GENERAL SUMMARY

DEL / FRA / MAD P2
NOISE WALL REPAIR

NOISE WALL REPAIR PLAN & ELEVATION
LOCATION 5: DEL-US42-6.99

NOISE WALL REPAIR PLAN & ELEVATION
LOCATION 6: FRA-IR71-29.63

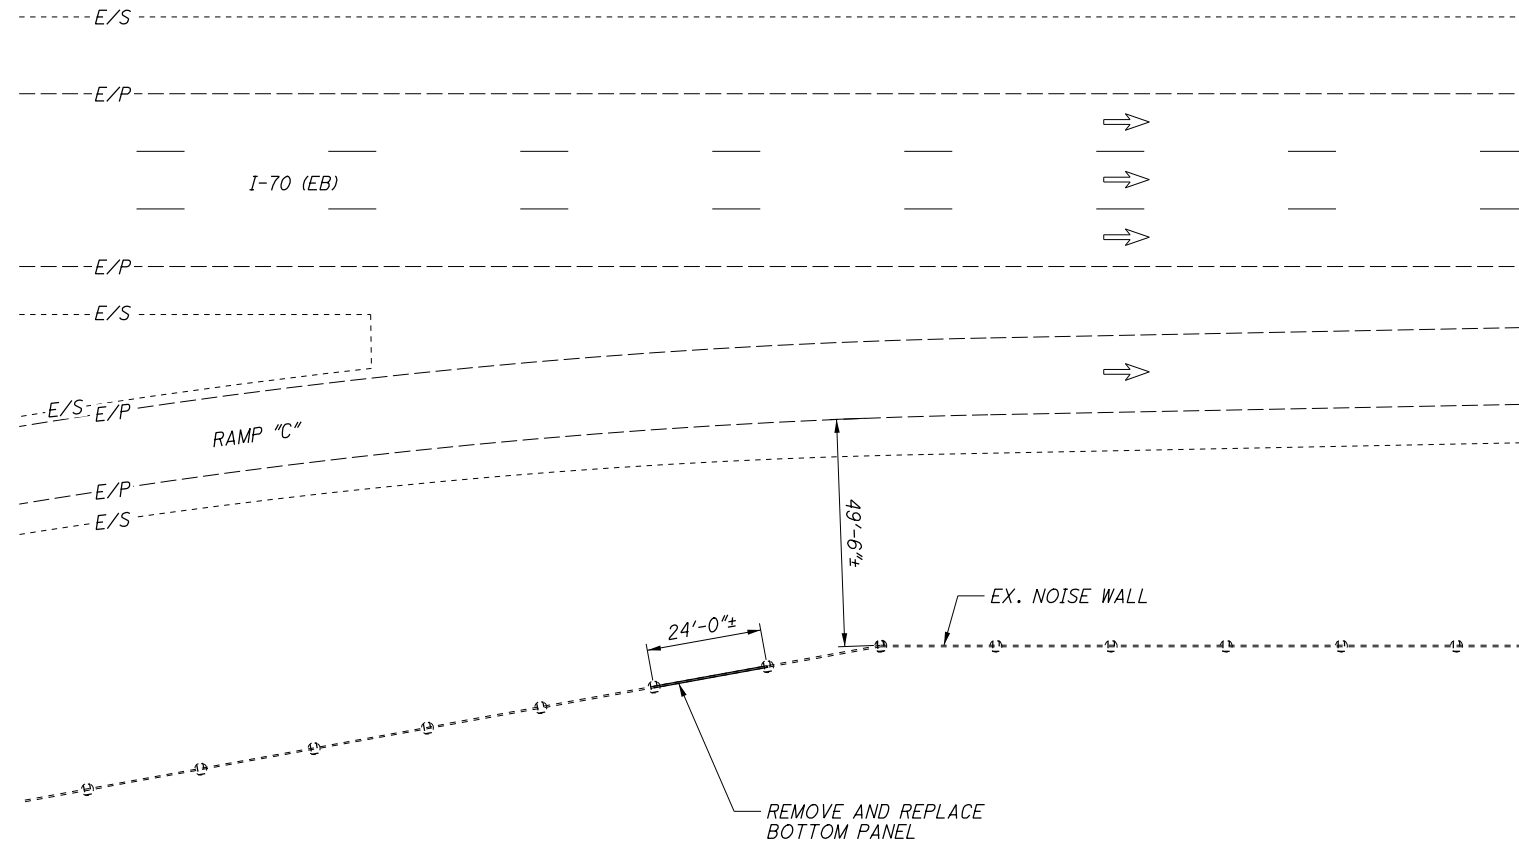
1 06-08-2021 ALUMINUM PANEL REPLACEMENT PAY ITEM ADDED AND UPDATED QUANTITY FOR NOISE BARRIER, ALUMINUM PANEL REMOVAL AND REUSE

PLAN

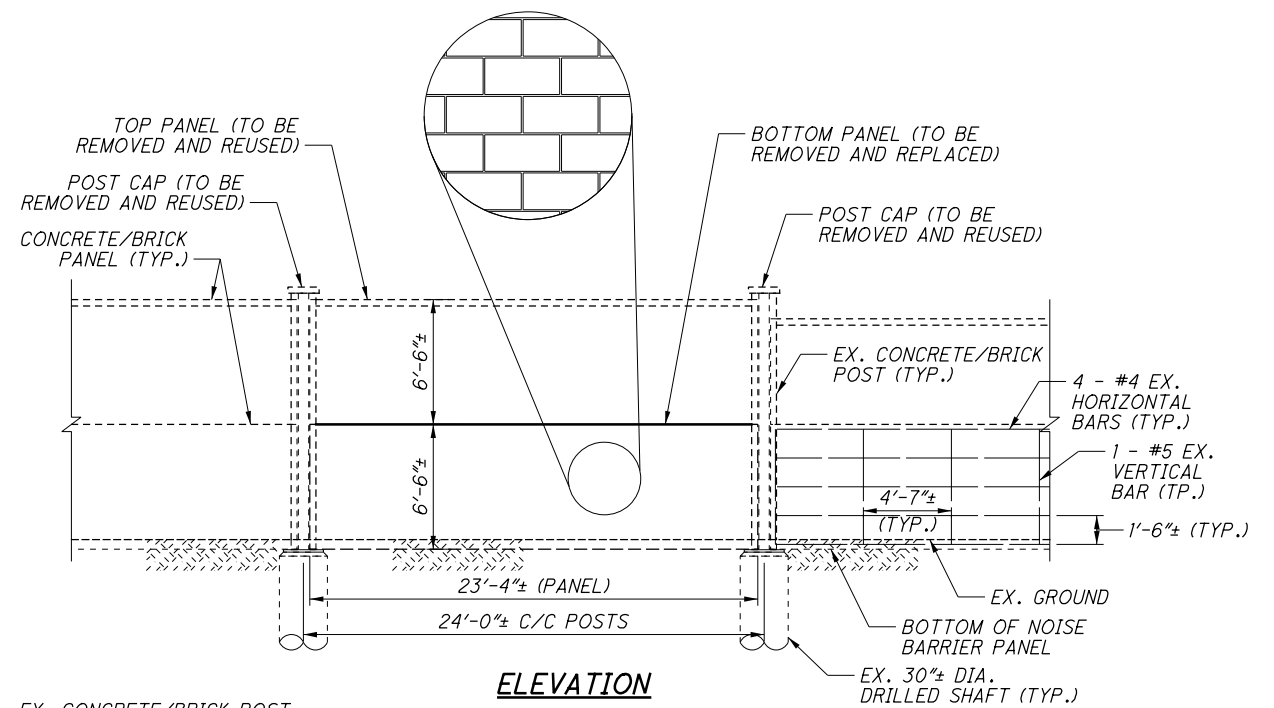
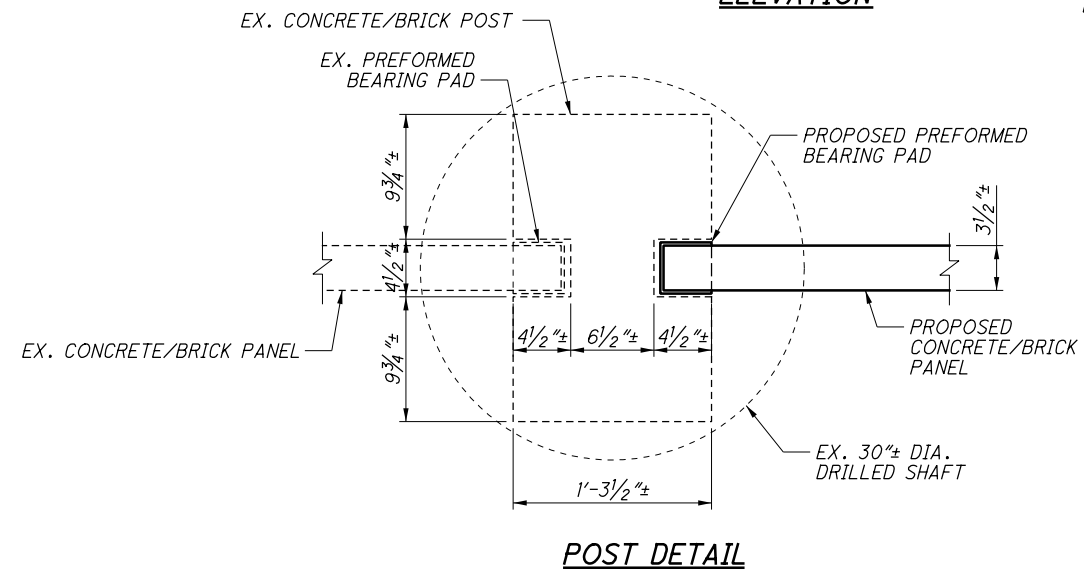
06-08-2021 NOTE ADDED

4. THE CONTRACTOR SHALL BE PERMITTED TO USE A FORMLINED PRECAST PANEL PROVIDED THAT THE PANEL IS MODIFIED TO FIT THE EXISTING CONCRETE/BRICK POST 4 1/2" SLOT AND THE FORMLINED FINISH IS FLUSH WITH THE EXISTING FACE OF THE TOP PANEL. THESE DETAILS MUST BE APPROVED BY THE ENGINEER PRIOR TO CASTING THE PANEL. THE COST SHALL BE INCLUDED IN THE UNIT PRICE BID FOR ITEM 606, SPECIAL - NOISE BARRIER REMOVAL AND REPLACEMENT.

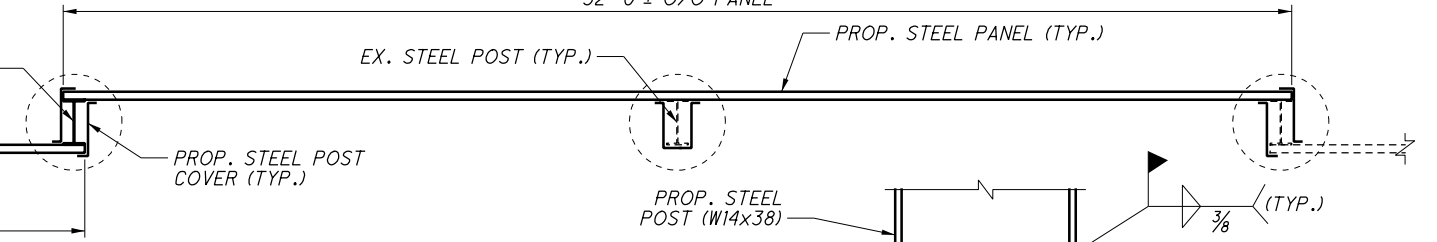
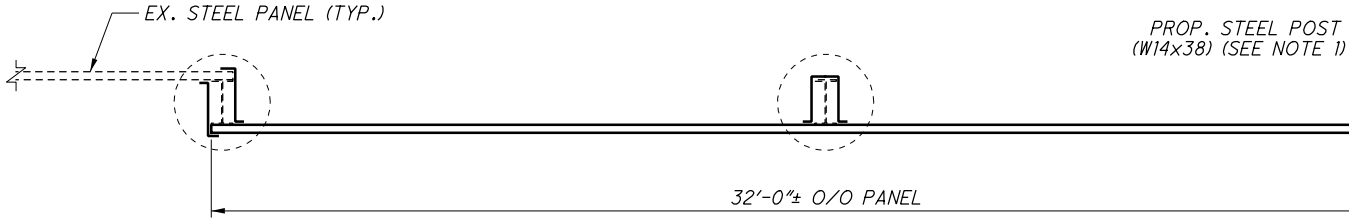
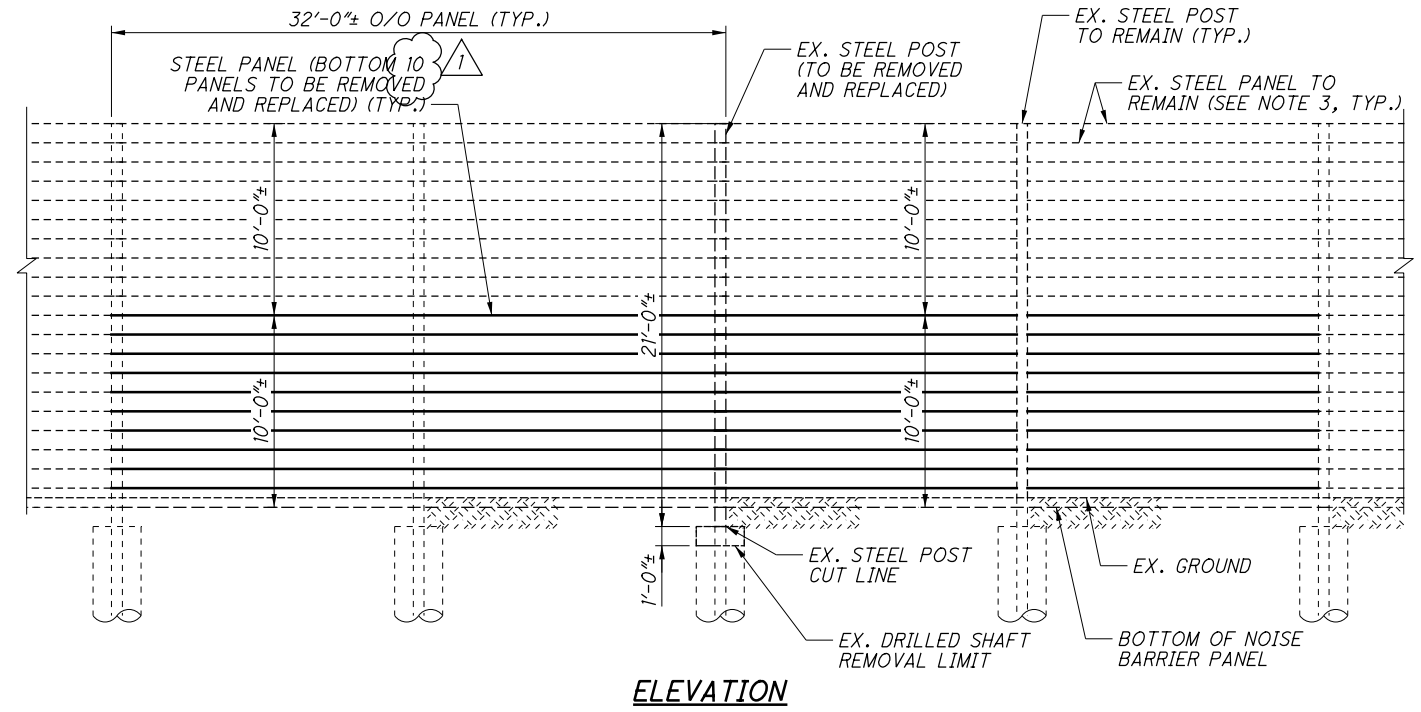
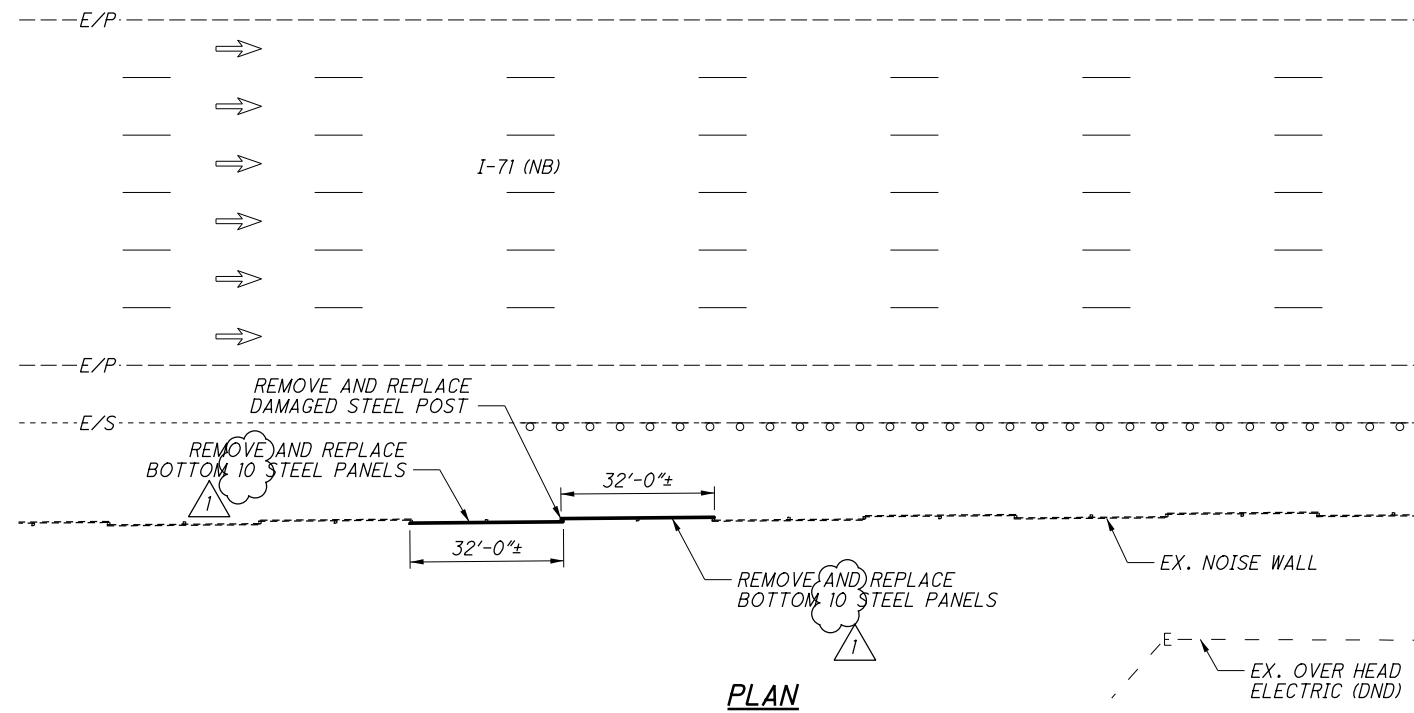
06-08-2021 PANEL REPLACEMENT DETAILS REVISED
NOISE BARRIER, ALUMINUM PANEL REMOVAL AND REUSE QUANTITY UPDATED
NOISE BARRIER, ALUMINUM PANEL REPLACEMENT NOTE AND PAY ITEM ADDED

3. THE REPLACEMENT PANELS (ACOUSTAL ALUMINUM NOISE BARRIER, DIMENSIONS 7'-10" x 1'-0" x 3", FEDERAL COLOR NO. 17778 - LIGHT NEUTRAL) ARE TO BE FABRICATED BY FADDIS CONCRETE PRODUCTS, TEL NO.: (610) 269-4685. THE CONTRACTOR SHALL CONFIRM PANEL PAINT COLOR AND MEASUREMENTS. THE COLOR, MATERIAL TYPE AND PATTERN OF REPLACEMENT PANELS SHALL MATCH THE EXISTING PANELS. THESE DETAILS SHALL BE APPROVED BY THE ENGINEER PRIOR TO FABRICATION AND ORDERING THE PANELS. INSTALL 2" DIA. FOAM BACKER ROD AND L3x3x1/4" ALUMINUM ANGLE WITH 1" HEX HEAD STEEL SELF DRILLING TAPPING SCREWS AS SHOWN ON THE PLANS.

THE COST FOR THE ABOVE WORK SHALL BE INCLUDED IN THE UNIT PRICE BID FOR ITEM 606, SPECIAL - NOISE BARRIER, ALUMINUM PANEL REPLACEMENT, AND SHALL INCLUDE ALL LABOR, EQUIPMENT, MATERIALS AND INCIDENTALS NECESSARY TO COMPLETE THE WORK.

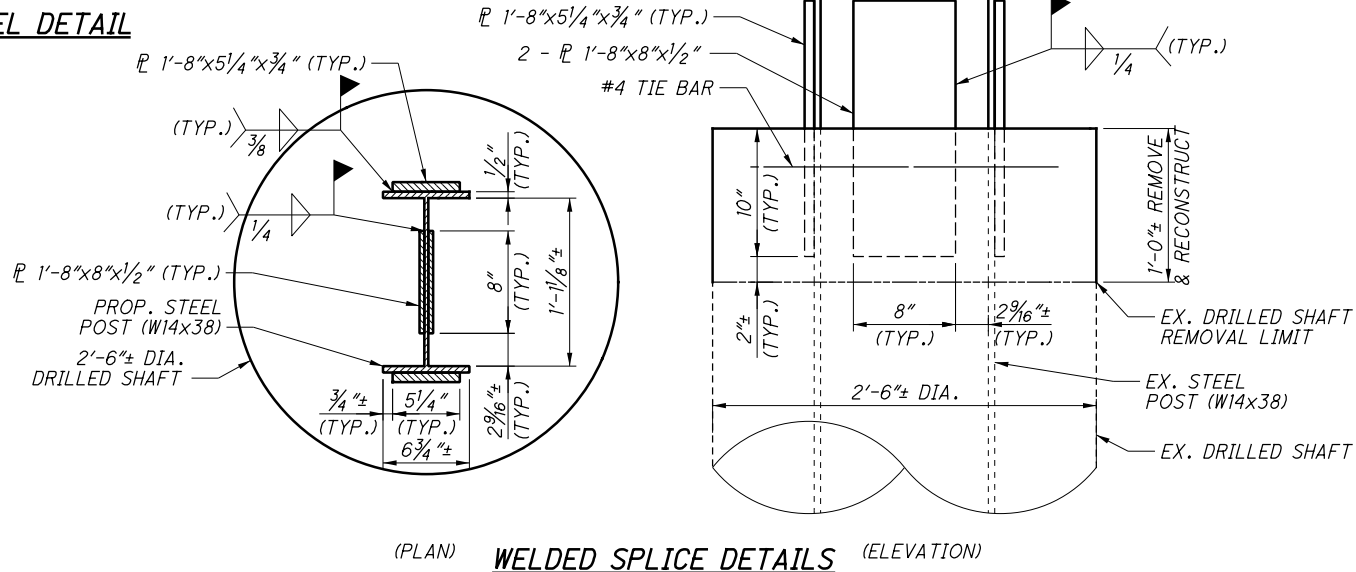
1 06-08-2021 NUMBER OF PANELS UPDATED

THE COST FOR THE ABOVE WORK SHALL BE INCLUDED IN THE UNIT PRICE BID FOR ITEM 606, SPECIAL - NOISE BARRIER, STEEL POST REMOVAL AND REPLACEMENT, AND SHALL INCLUDE ALL LABOR, EQUIPMENT, MATERIALS AND INCIDENTALS NECESSARY TO COMPLETE THE WORK.
2. REMOVE AND REPLACE BOTTOM 10 STEEL PANELS IN 2 BAYS. CONTRACTOR SHALL CONFIRM PANEL MEASUREMENTS.
